MEMORANDUM

SUBJECT: CDR-22-006 – Sterling Ranch Road Bridge
Second Submittal

Engineering Division

Response to comment 3. a and b below by Contech:

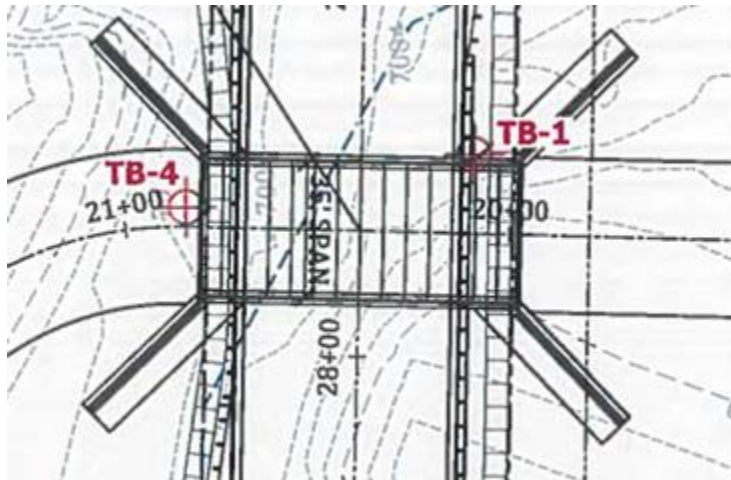
1. See GEC redlines. **Partially resolved; see updated GEC redlines. Revised**
2. **Resolved.**
3. Clarify whether the footings are to be constructed only on sandstone subgrade. Please provide a formal response to these comments. **Unresolved. Please include the memo from Entech in the EDARP submittal. Entech Addendum provided with this submittal**
 - a. Section 5.1.1 of the Subsurface Soil Investigation states that extensive subgrade improvements are anticipated and a maximum ultimate bearing pressure of 5,000 psf is recommended, but for undisturbed sandstone, the allowable bearing capacity is 5,800 psi. The footing design report states that Ultimate Bearing Resistance is 14,500, resulting in a factored bearing resistance of 8,700 psf. Please clarify.
 - b. Address how the footings will tie in to undisturbed sandstone if it is higher or lower than the bottom of the footings.

The foundations were designed based on Entech's Bearing Capacity Table with the bottom values. 5 foot embedment in rock with 8500 psf allowable bearing capacity. Per the test borings (TB1) sandstone is only 4' below grade.

Bottom of footings are at 6996.
